March 10, 1975

Subject: Dresden Station Environmental
 Technical Specification
 NRC Dkts. 50-237 and 50-249

Subject: Response to NRC Requests (dated Feb. 4, 1975)
re. Dresden Environmental Technical Specifications

PLAN
DISCHARGE FLUME CELLS
 TOP OF CELL 1 CHEST PIPE EL. 810'-0"
 TOP OF CELL 2 EL. 810'-0" UNLESS NOTED
 TOP OF CASTING EL. 811'-4 1/2"
 SCALE: 1/4" = 1'-0"

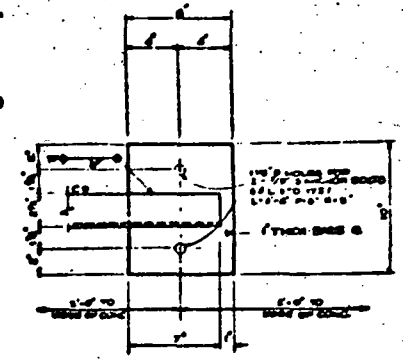
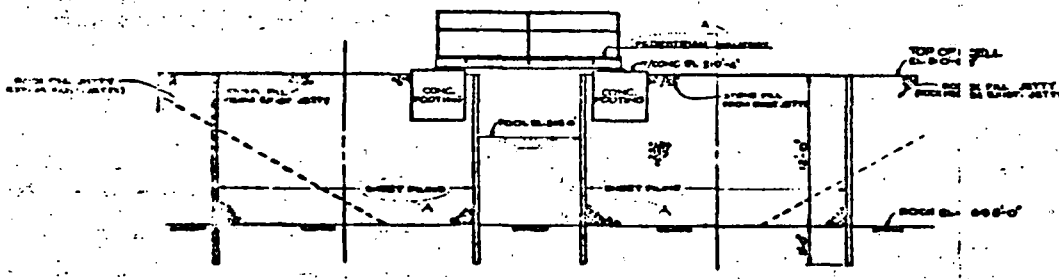
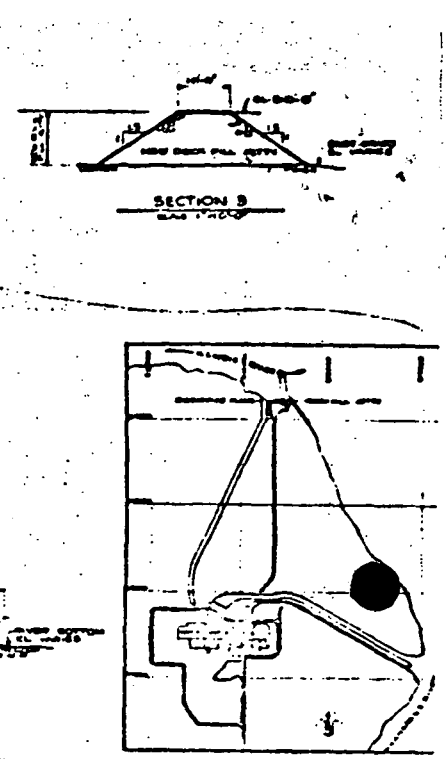
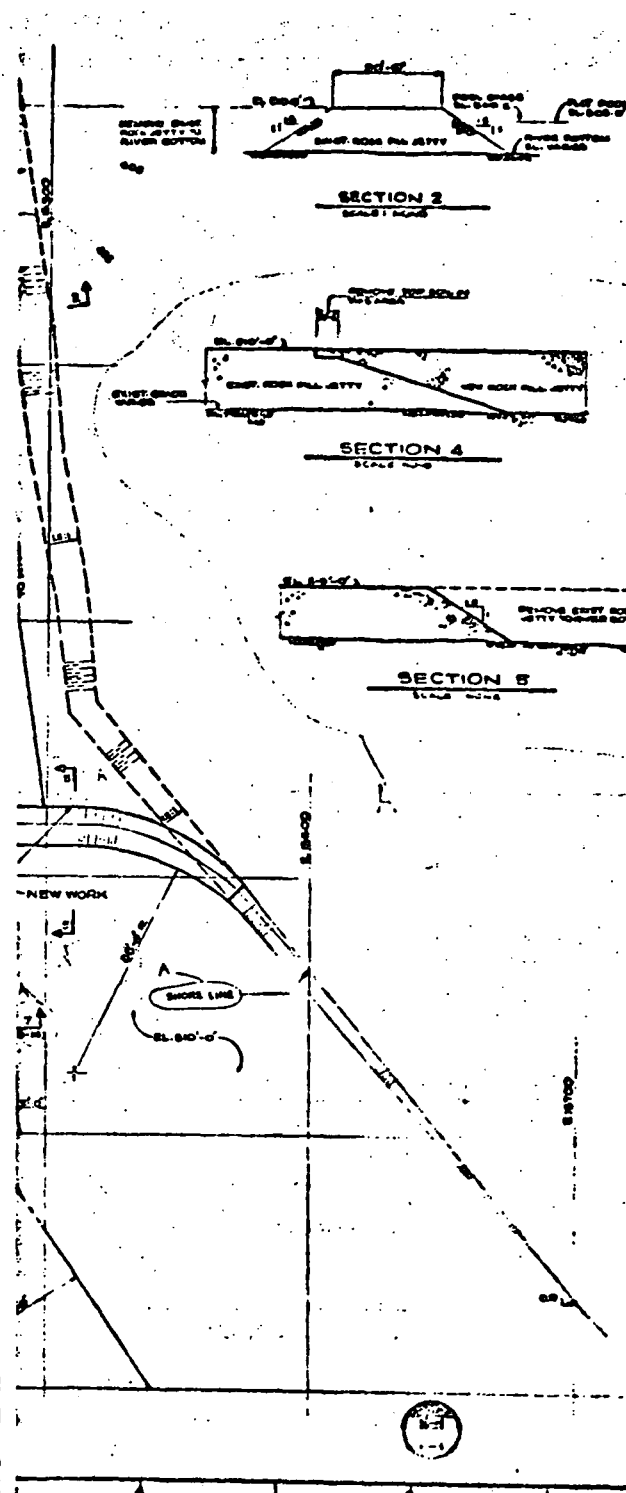
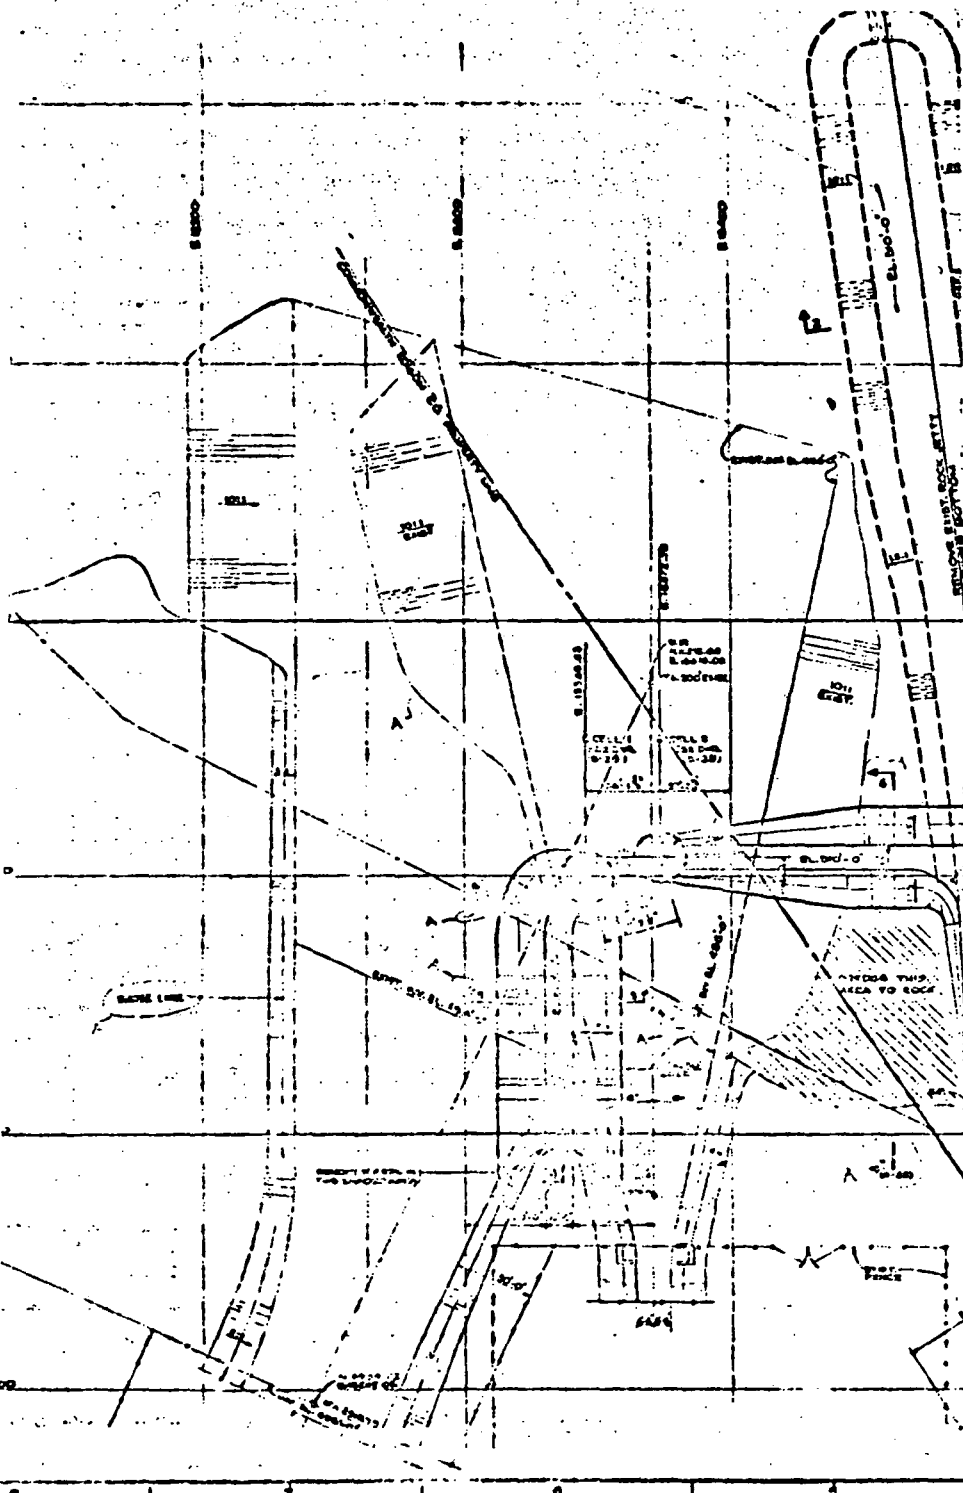
4. Construction of the modification to the Unit 1 discharge canal outfall has been completed. The modification consisted of the removal of an existing rock jetty (see drawing no. B-27 and B-28 attached) and the installation of a slot jet outfall. The new outfall consists of two circular cells twenty feet in diameter. The cells are separated by about eight feet. This separation forms the slot which creates the high velocity discharge necessary for rapid mixing. The cells are formed of sheet metal piling, filled with rubble obtained when the jetty was removed and are capped with concrete. The cells are tied back to the shore with rock filled dikes. The Unit 2, 3 canal was not modified. The mode of operation is for Unit 2, 3 blowdown and the Unit 1 circulating water to be discharged from their respective canals.
5. The chlorine data is attached.
